UNITED STATES
NUCLEAR REGULATORY COMMISSION
WASHINGTON, D.C. 20555-0001

SAFETY EVALUATION BY THE OFFICE OF NUCLEAR REACTOR REGULATION
APPLICATION OF LEAK-BEFORE-BREAK STATUS TO PORTIONS OF THE SAFETY
INJECTION AND SHUTDOWN COOLING SYSTEM
NORTHEAST NUCLEAR ENERGY COMPANY
MILLSTONE NUCLEAR POWER STATION, UNIT NO. 2
DOCKET NO. 50-336

Figure 2: Loop 1B Safety Injection Line

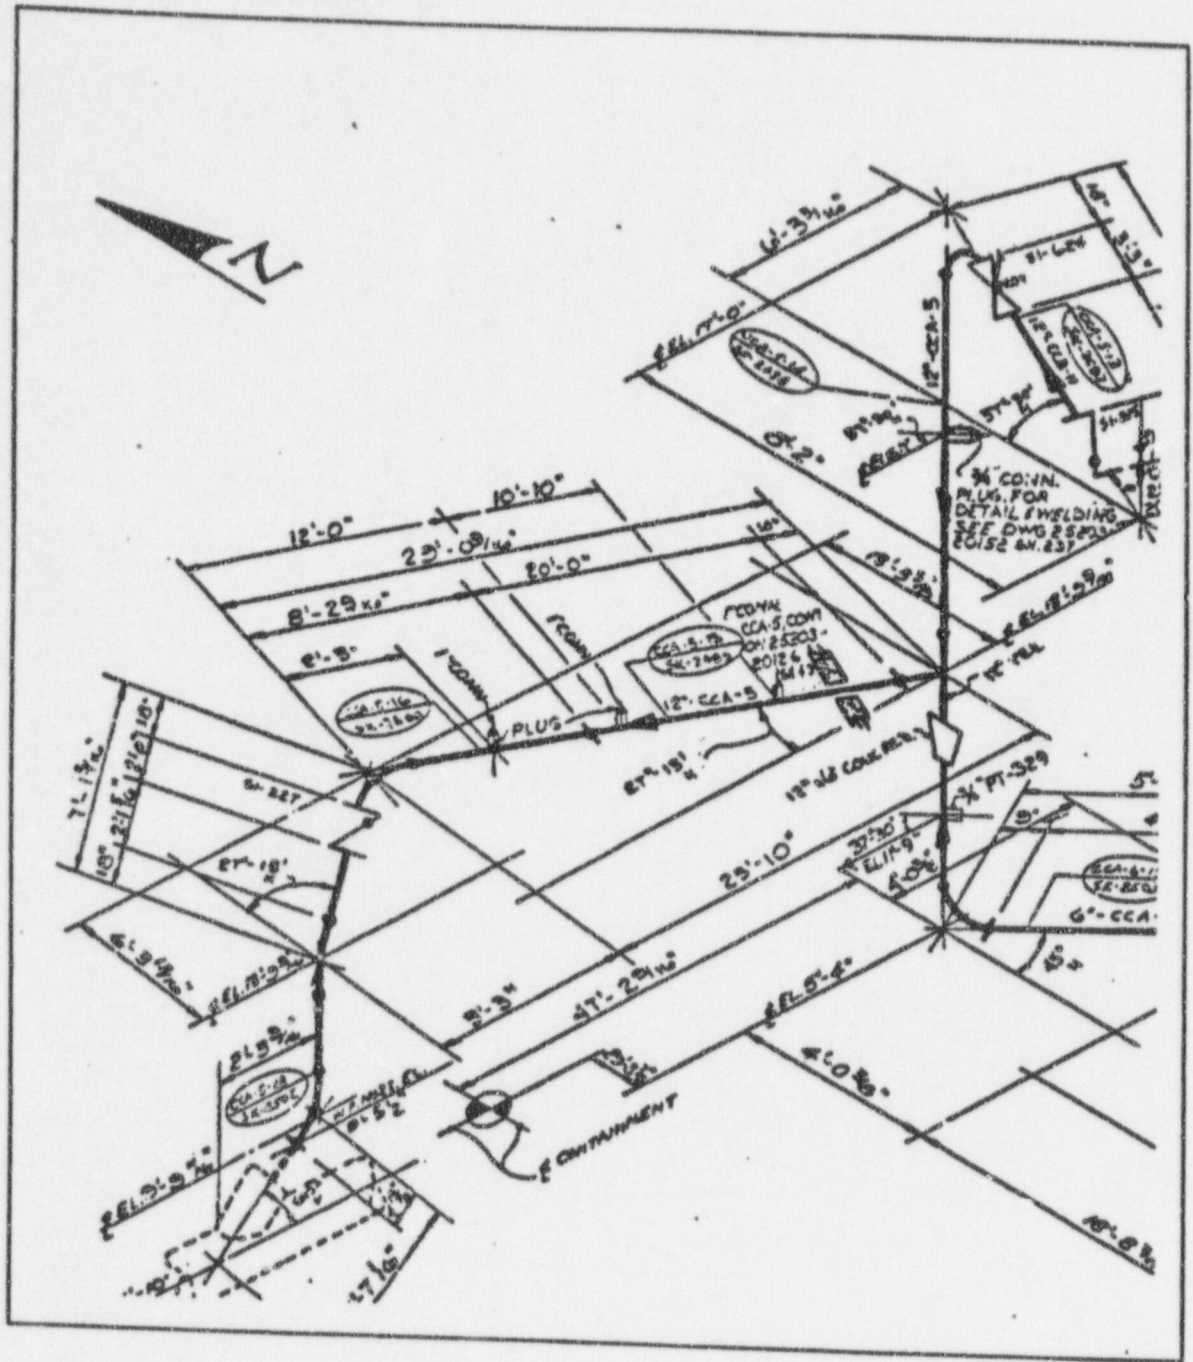
Based on the licensee's results and the loadings supplied by the licensee, the staff concluded that the locations which would be expected to be limiting for the SIS piping evaluation would be nodes 170 (at loop 1B nozzle location) or node 175 (piping to elbow SS weld location). At node 170, the staff's evaluation considered both the possibility of a crack in the CSS safe end between the carbon steel nozzle and the wrought SS piping or a flaw in the SS weld between the safe end and the piping. The staff's evaluation showed of these two possibilities, the postulation of a flaw in the weld metal provided a bounding analysis when compared to a flaw in the safe end. The weld metal evaluation is detailed below and the safe end evaluation can be summarized by noting that the critical flaw was found to be 11.8 inches in length under SSE+NOP loading conditions while the 10 gpm leakage flaw was found to be 4.35 inches, providing a margin of 2.71 on the crack sizes. The leakage flow in the safe end was stable under $\sqrt{2} * (SSE+NOP)$ loads.

Since the weld at node 170 existed between the aged CSS safe end and the wrought 316 SS piping while the weld at node 175 was between two sections of 316 SS piping, the staff evaluated the allowable critical flow size for the welds in two parts. Since the LBB.ENG3 code does not provide an option to specify different base materials stress-strain properties on each side of the weld, the staff first evaluated the weld by assuming that the weld was flanked on both

side of the weld, the staff first evaluated the weld by assuming that the weld was flanked on both sides by the aged CSS of the safe end. This resulted in a calculated critical flaw size of 12.4 inches. Then it was assumed that the weld was flanked by the wrought 316 SS piping material. Four different wrought 316 SS stress-strain property representations were used: two of which assumed "typical" yield strength (YS) and ultimate tensile strength (UTS) properties for the material (YS = 25 ksi, UTS = 75 ksi) and differed only in their Ramberg-Osgood parameterizations ($\alpha = 6.9$, $n = 4.8$ or $\alpha = 5.8$, $n = 3.6$), one submitted by the licensee in Table 4-3 of report SIR-98-048 (YS = 29.6 ksi, UTS = 86.6 ksi [corrected], $\alpha = 12.0$, $n = 4.8$) and one which used ASME Code minimum strength values at the system's operating temperature (YS = 18.8 ksi, UTS = 71.8 ksi). These three analyses gave critical flaw sizes of 7.70, 8.30, 7.50, and 11.20 inches, respectively, with the nonconservative critical flaw size based on the ASME Code minimums as the outlier. Based on these results, the staff concluded that the appropriate critical flaw size determined by assuming 316 SS properties would be an average of the three non-Code minimum calculations, 7.83 inches. Furthermore, it was concluded that node 175 (where the NOP and SSE loads were essentially equivalent to those at node 170), which would be directly represented by the 7.83-inch critical flaw size, would be the bounding location inasmuch as a calculation based on the consideration of the CSS safe end properties on one side of the weld at node 170 and would be expected to lengthen the critical flaw size.

The staff then used the PICEP code to determine the leakage flow size for node 175. Using the surface roughness value that the staff has used in previous LBB evaluations of $e = 0.003$ inch, the staff determined that 10 gpm of leakage would be expected from a 4.35-inch through-wall flaw. Therefore, the margin between the critical flaw size and the leakage flow size for node 175 was found to be $(7.83 / 4.35) = 1.8$, slightly less than the margin of 2 recommended in NUREG-1061, Vol. 3. In addition, the leakage size flaw was found to be stable only up to $1.36 * (SSE+NOP)$ loads instead of $1.414 * (SSE+NOP)$ loads.

However, in previous LBB evaluations, the staff has concluded that margins of slightly less than 2 on the critical-to-leakage flow size are acceptable provided that a full margin of 10 is maintained on the leakage uncertainty. It is the staff's position that relaxation from the guidance written in 1984 on this point and on the margin of $\sqrt{2}$ on the loads for the leakage flow stability evaluation is acceptable based on the work that has been completed in the areas of piping fracture (e.g., the International Piping Integrity Research Group work) and the evaluation of minimum material properties to more appropriately bound the behavior of primary system piping materials. Therefore, the staff has concluded that the preceding evaluation confirms the licensee's conclusion that the analyzed portions of the Millstone 2 SIS piping will exhibit LBB behavior.

Figure 5: Shutdown Cooling Line

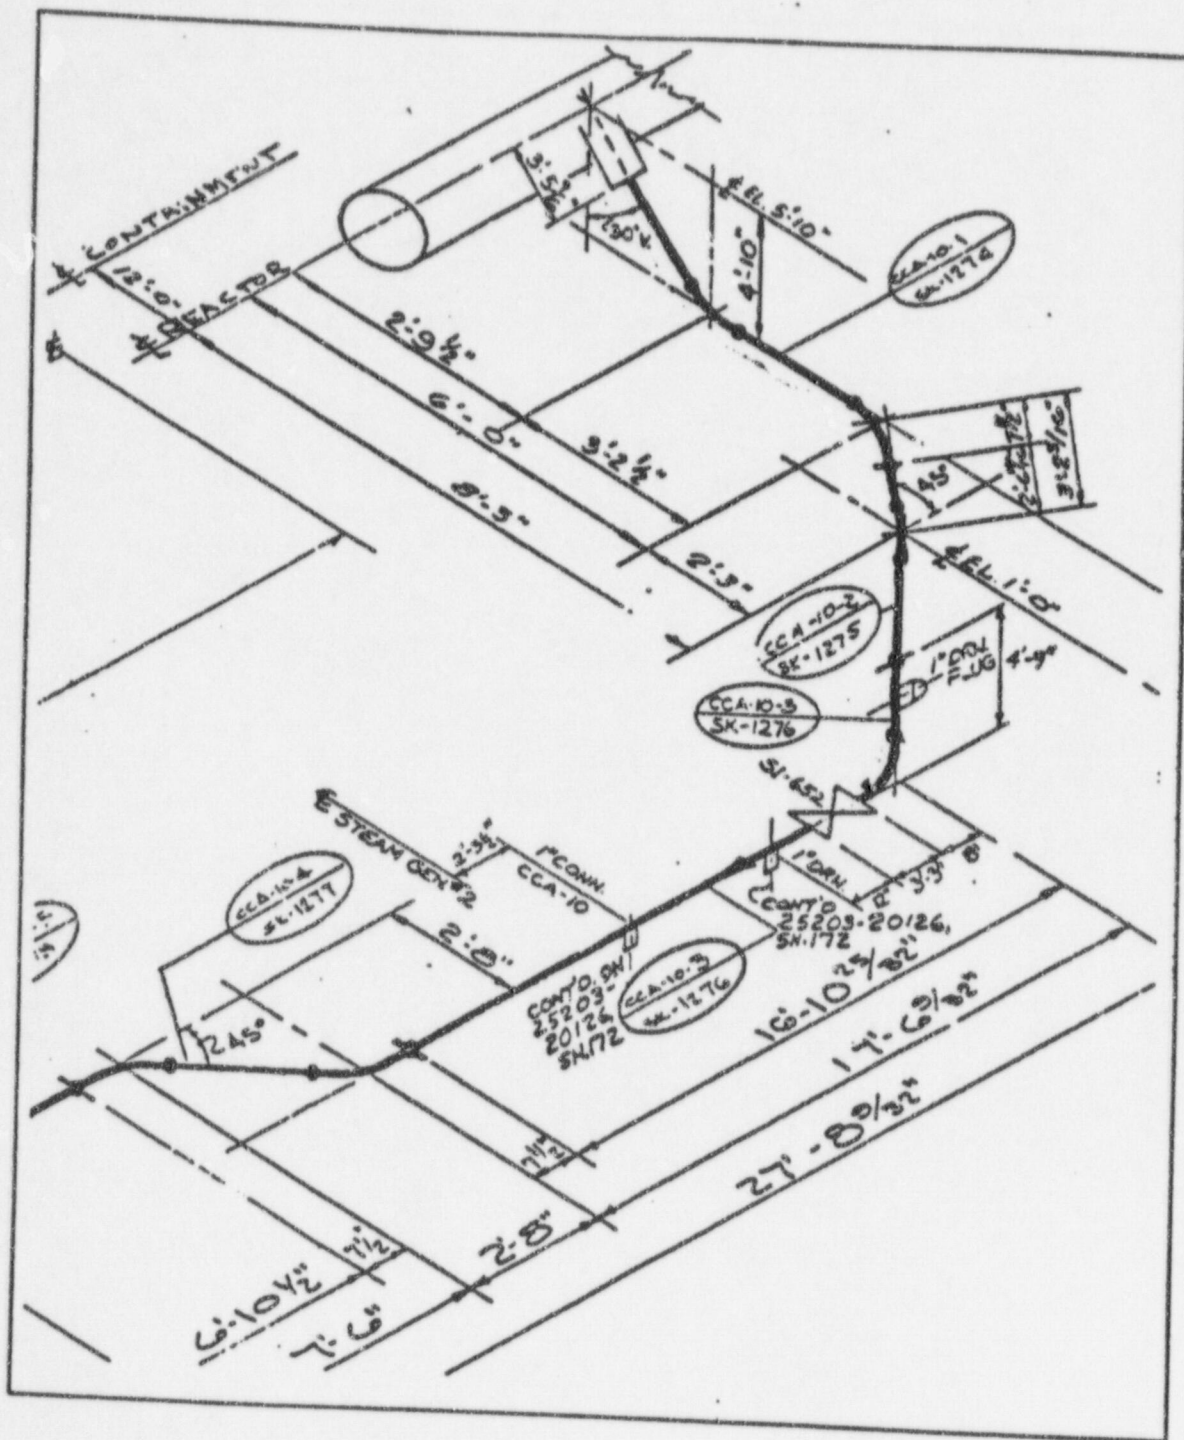
Based on the licensee's results and the loadings supplied by the licensee, the staff concluded that the locations that would be expected to be limiting for the SCS piping evaluation would be node 10 (at SCS nozzle location) or node 20 (piping to elbow SS weld location). At node 10, the staff's evaluation considered both the possibility of a crack in the CSS safe end between the carbon steel nozzle and the wrought SS piping or a flaw in the SS weld between the safe end and the piping. The staff's evaluation of node 10 was carried out with a method equivalent to that explained in detail for node 170 in the SIS evaluation (Section 4.3 of this SE). However, in this case, the staff's evaluation showed of these two possibilities the postulation of a flaw in the CSS safe end provided a bounding analysis when compared to a flaw in the weld adjoining the safe end. The safe end evaluation can be summarized by noting that using the LBB.ENG2 code gives a critical flaw size of 14.0 inches in length under SSE+NOP loading conditions while the 10 gpm leakage flow was found to be 6.75 inches, providing a margin of 2.07 on the crack sizes.

The leakage flow in the safe end was stable under $\sqrt{2}$ * (SSE+NOP) loads. For the SS weld adjoining the safe end at node 10, using the CSS properties in the LBB.ENG3 code, predicted a critical flaw size for the weld of 17.6 inches, while the use of "typical" 316 SS properties (YS = 25, UTS = 75, α = 6.9, r_1 = 4.8) predicted a critical flaw size of 15.0 inches. PICEP was then used to calculate a leakage flow size for the weld material of 6.70 inches for a margin on the crack sizes of 2.24. The leakage flow in the weld adjoining the safe end was stable under $\sqrt{2}$ * (SSE+NOP) loads.

For node 20, the staff reevaluated the predicted critical and leakage flow size since the applied loading under NOP and NOP+SSE conditions differed from those at node 10. Since node 20 represented a piping-to-piping weld location, the base metal properties used in the LBB.ENG3 analysis were the "typical" 316 SS properties (YS = 25, UTS = 75, α = 6.9, n = 4.8) and the predicted critical flaw size was 16.0 inches. PICEP was then used to calculate a leakage flow size for the weld material of 6.80 inches for a margin on the crack sizes of 2.25. The leakage flow in the weld and node 20 was stable under $\sqrt{2}$ * (SSE+NOP) loads.

Based on this information, the CSS safe end at node 10 was identified as the bounding location for the SCS LBB evaluation, and the staff concurred with the licensee's evaluation that the margins of 2 on crack size, 10 on leakage, and $\sqrt{2}$ on loadings were met for the analyzed portion of the system. Therefore, the staff has concluded that the preceding evaluation confirms the licensee's conclusion that the analyzed portions of the Millstone 2 SCS piping will exhibit LBB behavior.
